Architect's Supplemental Instructions

Architect's ASI No: 018

Project:
Webster University
Interdisciplinary Science
Building

Date Issued: 08/19/2016

LEVEL 05 ROOF FRAMING
PLAN

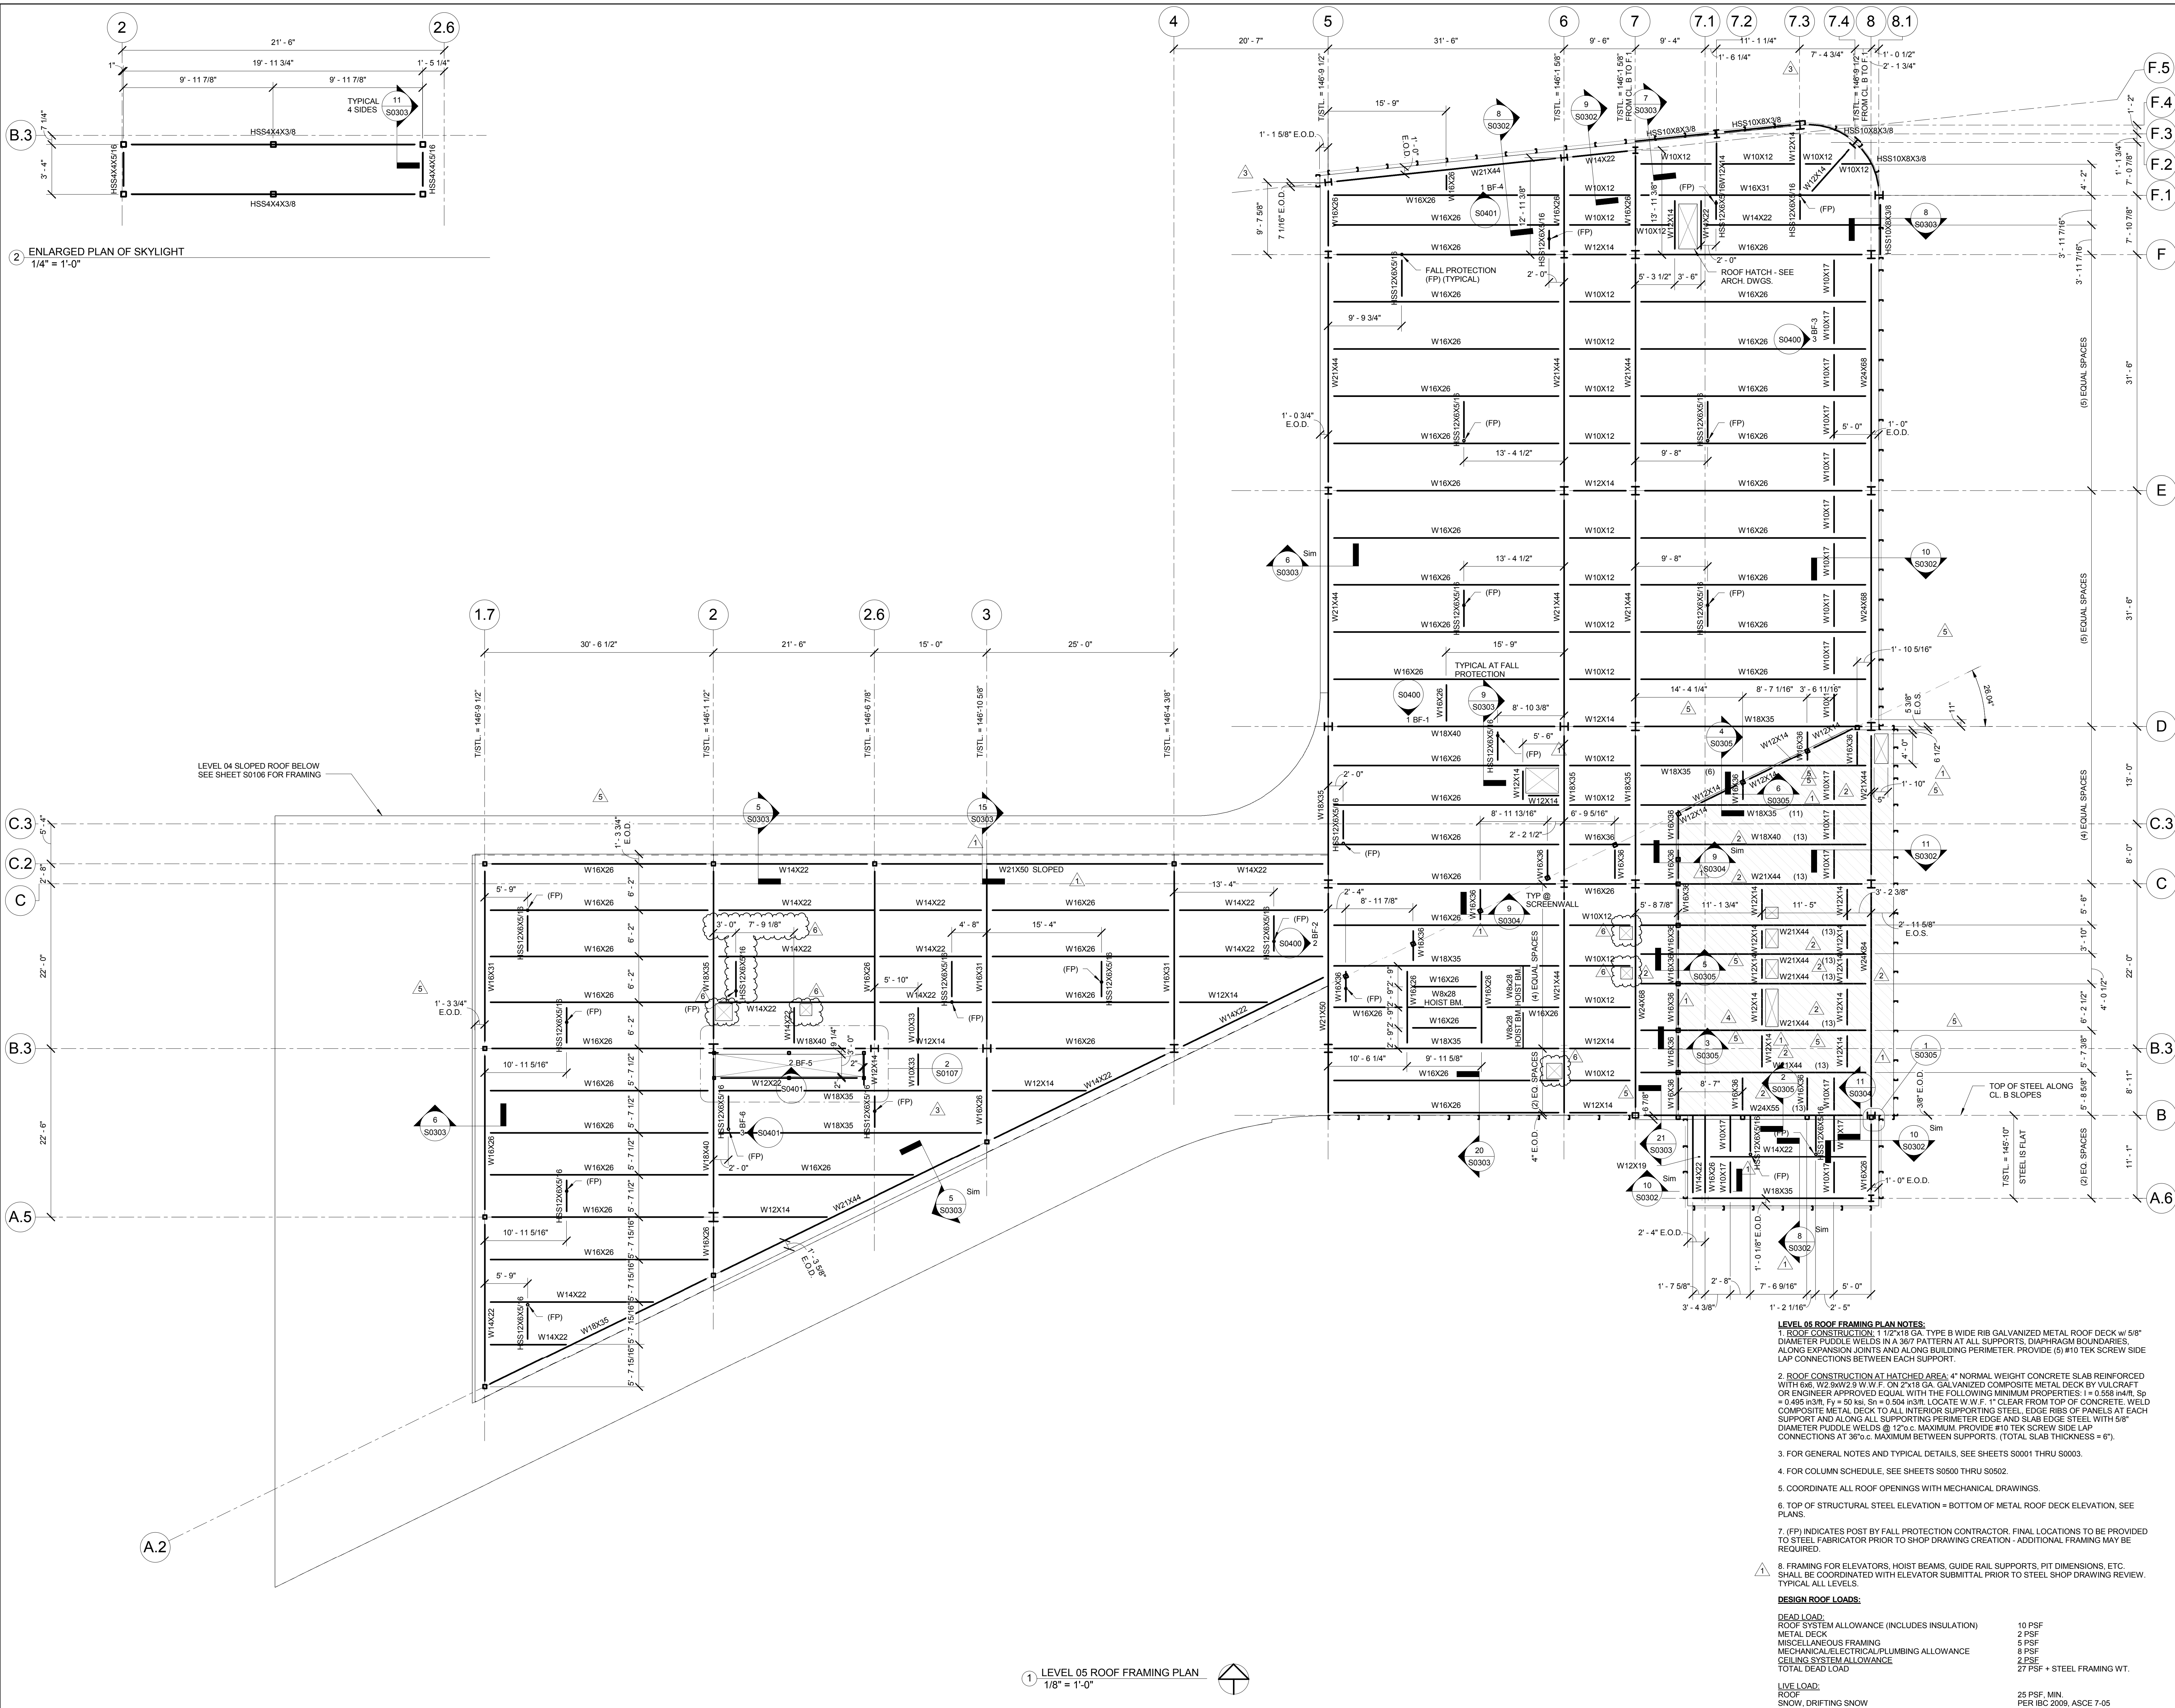
S0107:

Dimensional revisions for south inside curve, Relocation of fall protection beam, and opening revision/additions.

FRAMING SECTIONS AND
DETAILS

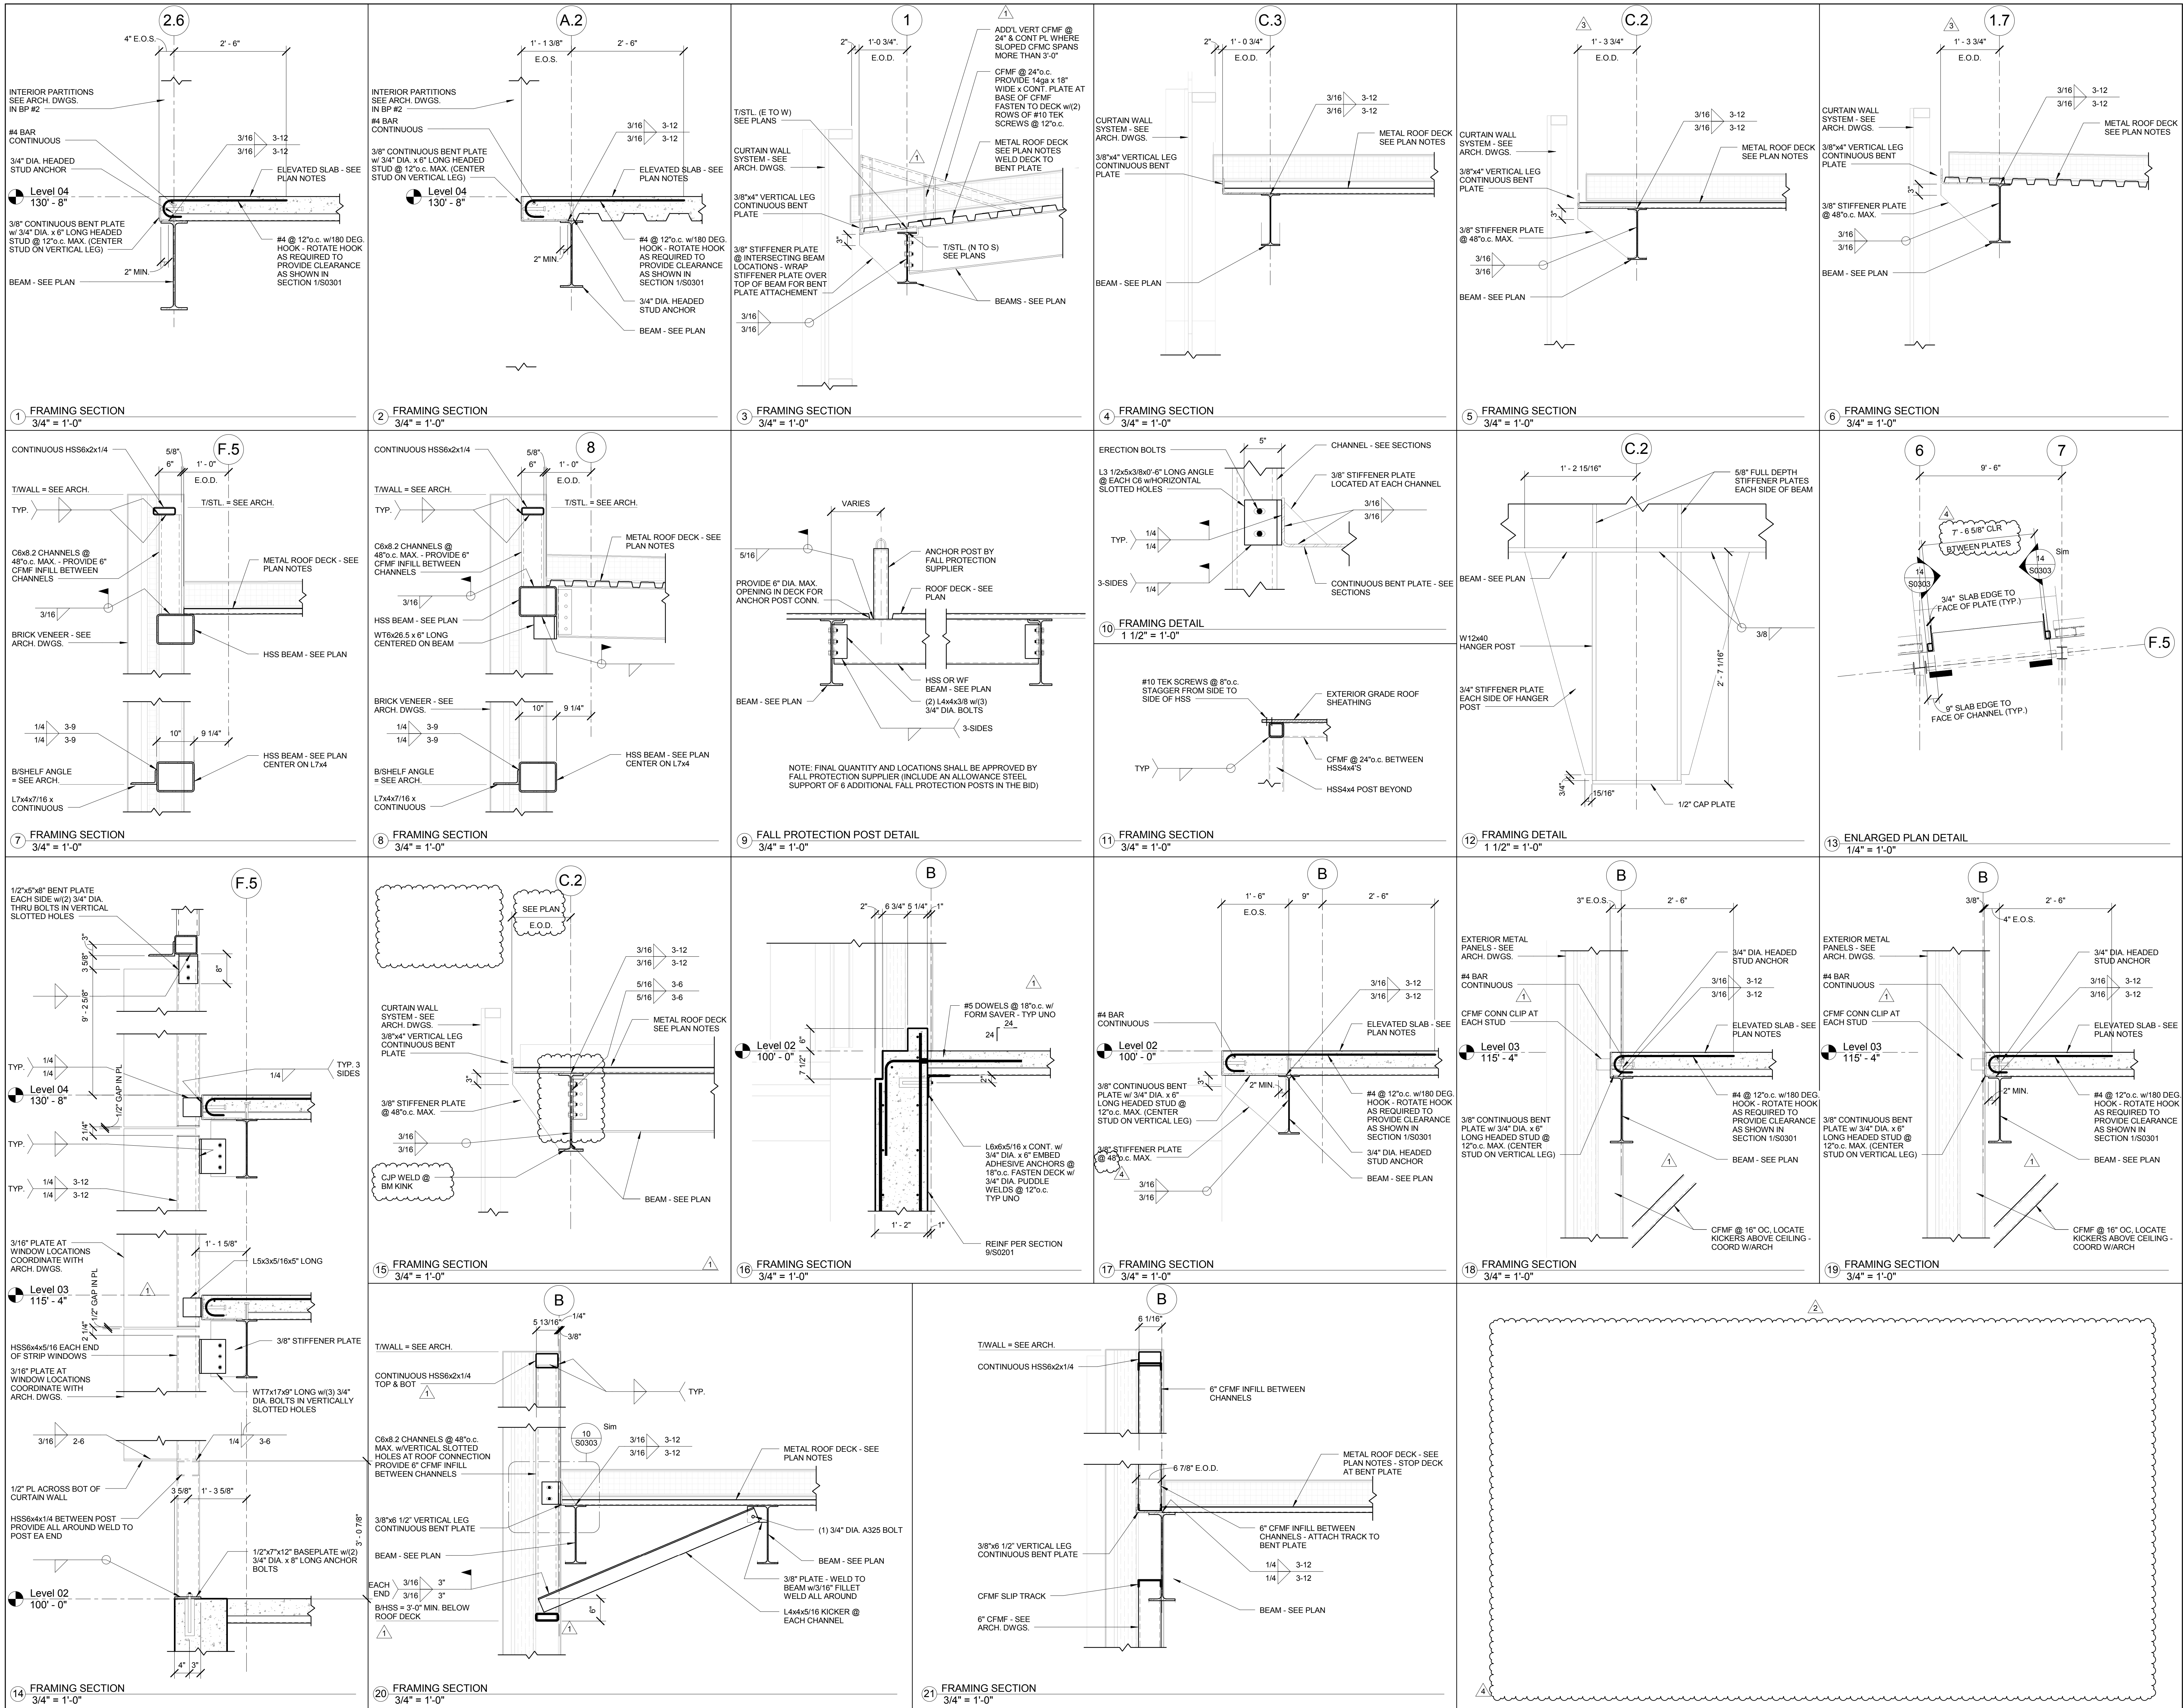
S0303:

Revisions to Detail numbers 13, 14, and 15. Deletion of 22.
